COUNTY OF LOUDOUN

MEMORANDUM

FROM: Todd Taylor, Environmental Engineer

**SUBJECT: ZMAP-2006-0011 & ZCPA-2006-0003
Stone Ridge Commercial - REVISED**

STONERIDGE COMMERCIAL - PROPOSED MILLSTREAM DRIVE / PUBLIC USE SITE

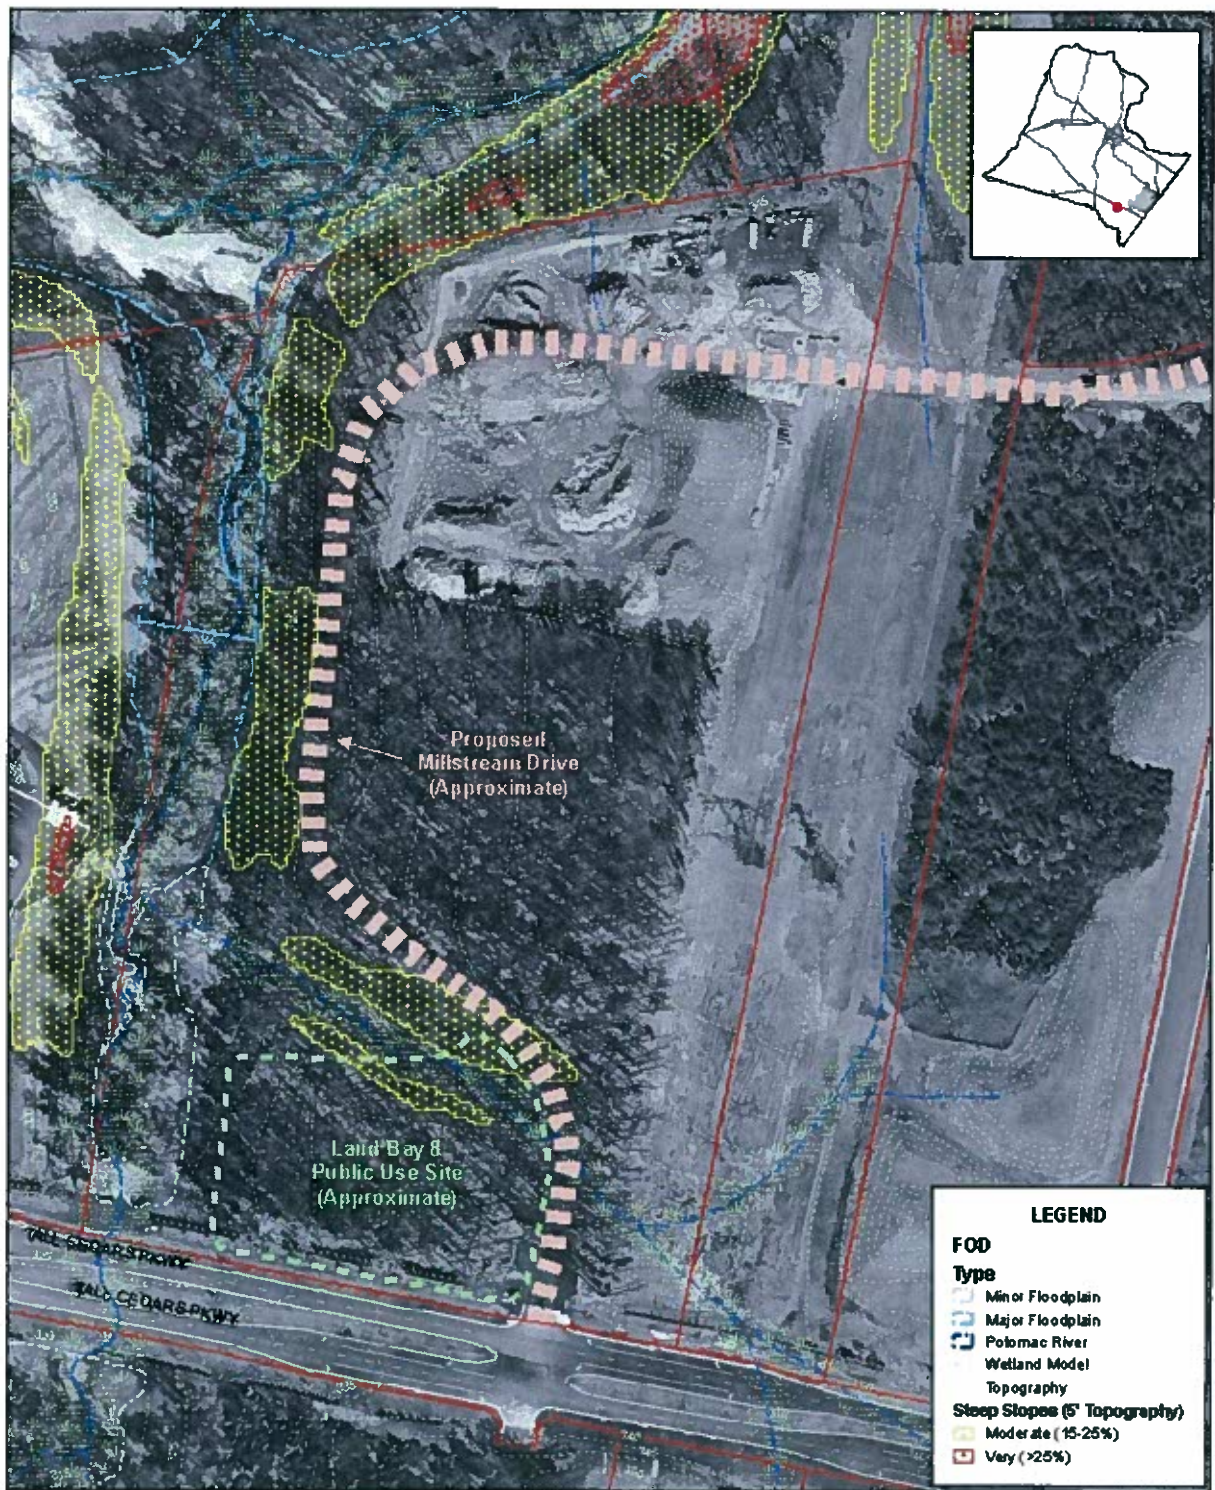
1. The proposed Public Use Site is limited in size at 3.4 acres, located in close proximity to the floodplain and steep slopes, predominantly covered with healthy deciduous trees, and has an existing stream system located in the rear of the property. These conditions do not present an ideal development site in relationship to protecting the County's green infrastructure. Staff recommends that the applicant consider another site for public use that would have less environmental impacts. Attachments A and B provide an aerial photograph with environmental overlays and supporting site photographs, respectively. Attachment A includes the approximate alignment of proposed Millstream Drive and the approximate boundaries of the public use site. [Revised General Plan (RGP) Forest, Trees, and Vegetation Policy 1; RGP River and Stream Corridor Resources Policies 11 and 23; and Revised 1993 Loudoun County Zoning Ordinance (Revised 1993 LCZO) Section 6-1211(E)(9)]

2. Staff recommends shifting the proposed alignment of Millstream Drive farther east to minimize impacts to moderately steep slopes. In addition, staff recommends committing to measures that will be used to protect the steep slopes areas and adjacent floodplain and stream during construction activities. Example measures include super silt fence, stabilization matting, and development phasing to avoid
